4396B-13

### Agilent 4396B RF Network/Spectrum/Impedance Analyzer

**Part Number Changes for Power Supply Switch Parts**

Figure 1 Replaceable Parts from Bottom View

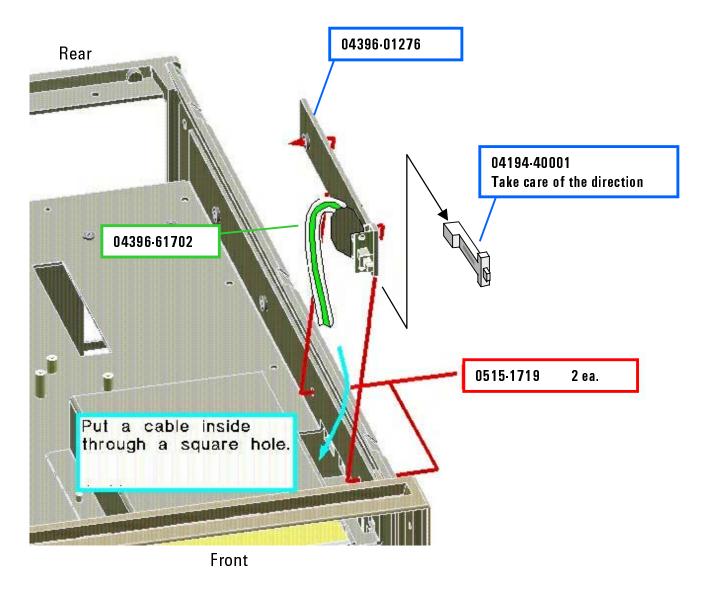
The power switch holder (P/N 04396-01274) and the power switch assembly (P/N 04396-61701) for the 4396B were obsoleted and replaced with new parts. Additionally, a new rod (P/N 04194-40001), which is inserted between the switch and LINE push-button, is set up.

When either the switch holder (P/N 04396-01274) or the switch assembly (P/N 04396-61701) is faulty, replace all the parts listed in Table 1 with the new parts shown in Table 2. Insert the rod (P/N 04194-40001) between the power switch and LINE push-button as shown in Figure 1.

Part Number	Qty.	CPL Description
04396-01276	1	Switch Holder
04396-61702	1	Switch Assembly
04194-40001	1	Rod for 04396-61702
0515-1719	2	Screw fixing 04396-01276 on the chassis
